APPLICATION NO.	FILING DATE	FIRST NAMED INVENTOR	ATTORNEY DOCKET NO.	CONFIRMATION NO.
10/563,660	01/06/2006	Miwa Okubo	09792909-6521	5305
26263 7590 01/02/2008 SONNENSCHN NATH & ROSENTHAL LLP P.O. BOX 061080 WACKER DRIVE STATION, SEARS TOWER CHICAGO, IL 60606-1080			EXAMINER ZIMMERMANN, JOHN P	
			ART UNIT 2861	PAPER NUMBER
			MAIL DATE 01/02/2008	DELIVERY MODE PAPER

Office Action Summary	Application No. 10/563,660	Applicant(s) OKUBO, MIWA	
	Examiner John P. Zimmermann	Art Unit 2861

DETAILED ACTION

F I G . 1

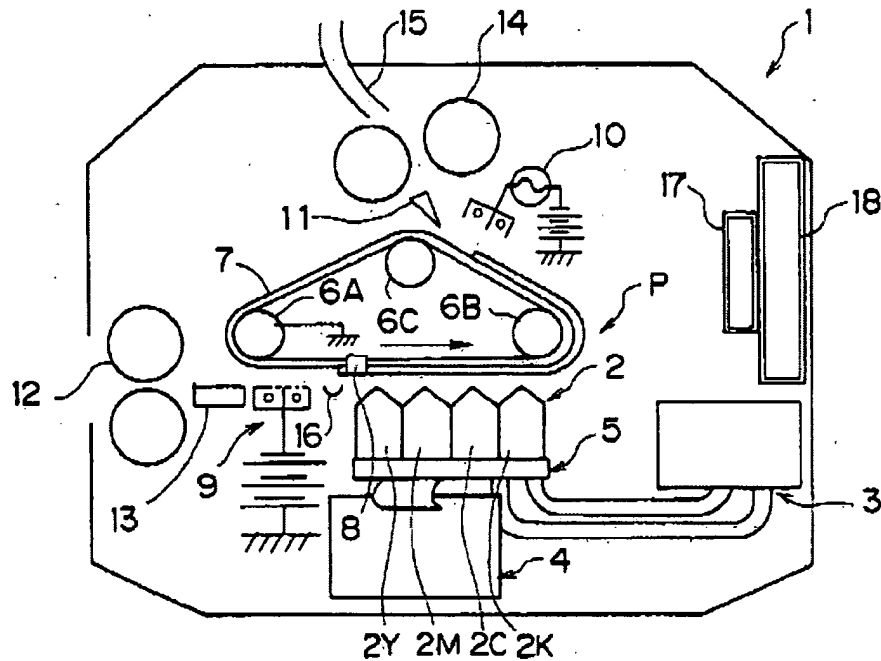
- c. As related to independent **claim 4**, Nakazawa et al. teach an ink-jet printer (Nakazawa et al. – Title) in which recording is executed by discharging inks of a plurality of colors from a discharge opening as droplets of ink to be attached onto a recording material (Nakazawa et al. – Background, Paragraph 5; Summary, Paragraphs 8 & 11; Detailed Description, Paragraph 58 and Figure 1, Reference #2Y, #2M, #2C & #2K, shown below).
